TITLE : AIR CONDITIONING - PRESSURE CONTROL AND MONITORING - FWC ACQUISITION  
INTERFACE CONNECT FWC TO RPWS TO PREVENT DOOR OPENING WITH RESIDUAL  
CABIN PRESSURE

MODIFICATION No. : 34673P8863

SERVICE BULLETIN No. : A320-21-1164

## SERVICE BULLETIN

Figure 1 Sheet 1  
Config. 01: Modification of the wiring in 80VU

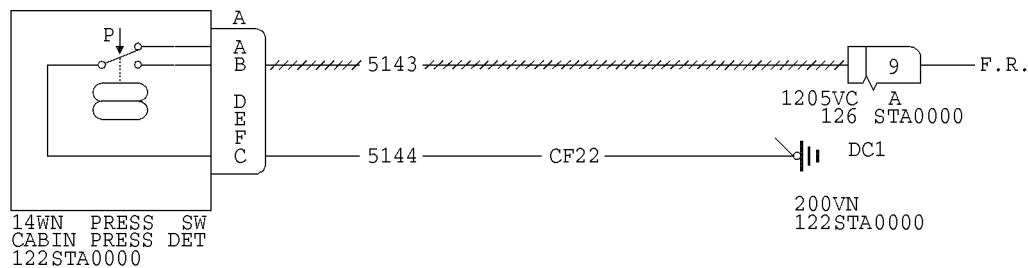
- (a) Modify the wiring in the Electronic Rack 80VU

- 1 Install the wires as shown on the wiring diagram, Figure 1 , Sheet 1 and as given in the Hook-Up Chart lines :

Figure 2 Sheet 1  
Config. 01: Modification of the wiring in Avionics Compartment

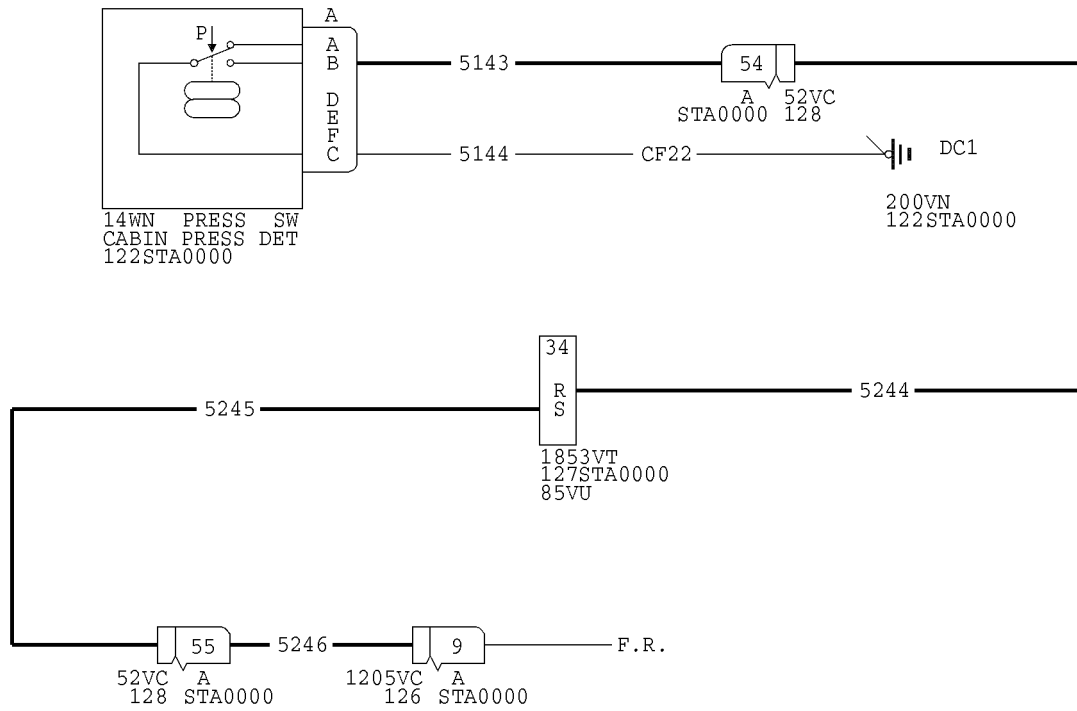
- 1 Remove the wire as shown on the wiring diagram, Figure 2 , Sheet 1 and as given in the Hook-Up Chart line :

Figure 2 Sheet 2  
Config. 01: Modification of the wiring in Avionics Compartment

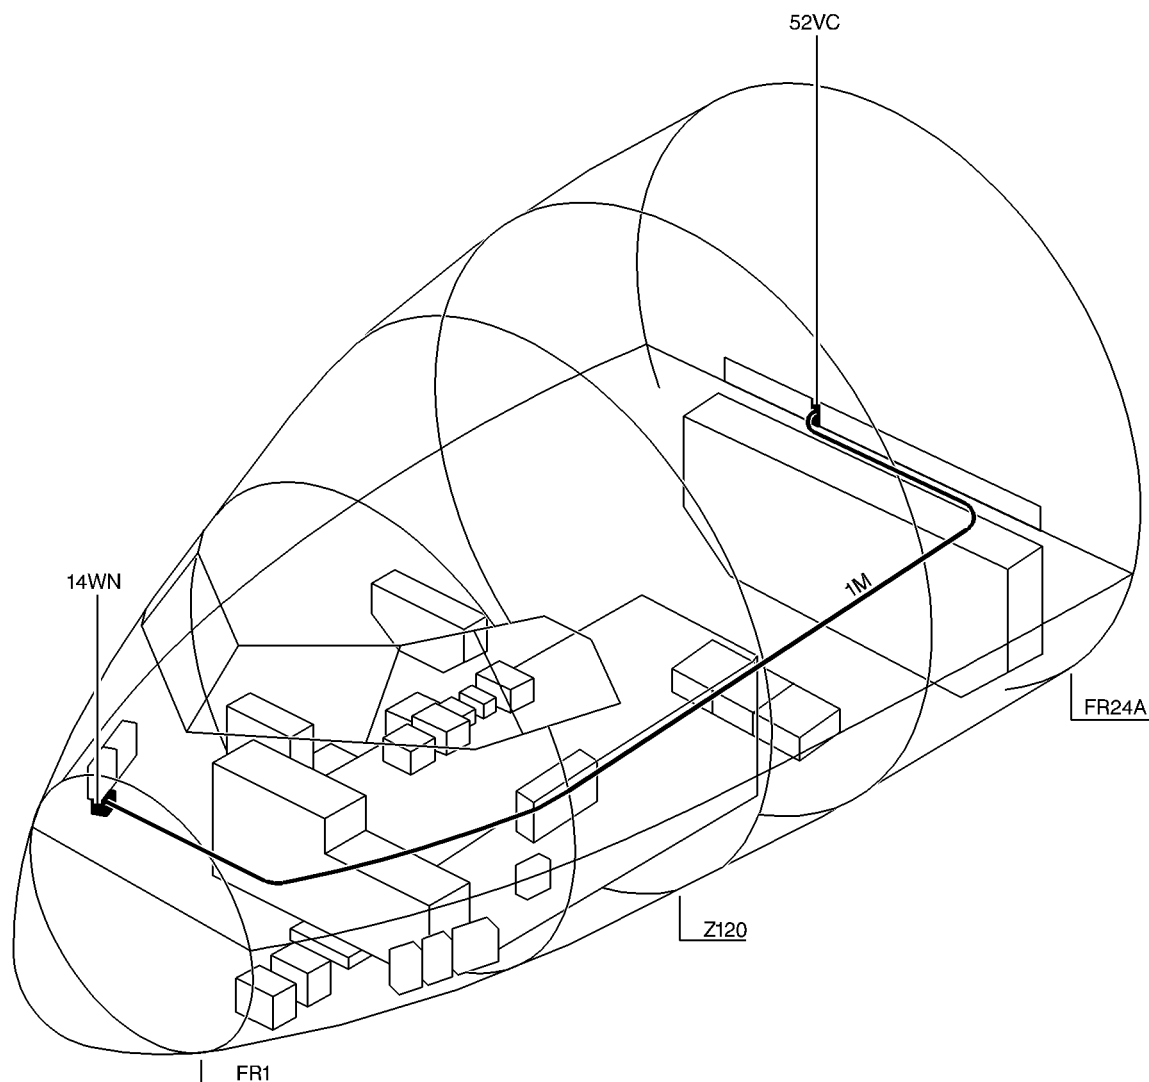
2 Install the wires as shown on the wiring diagram, Figure 2 , Sheet 2 , Sheet 3 and as given in the Hook-Up Chart lines :
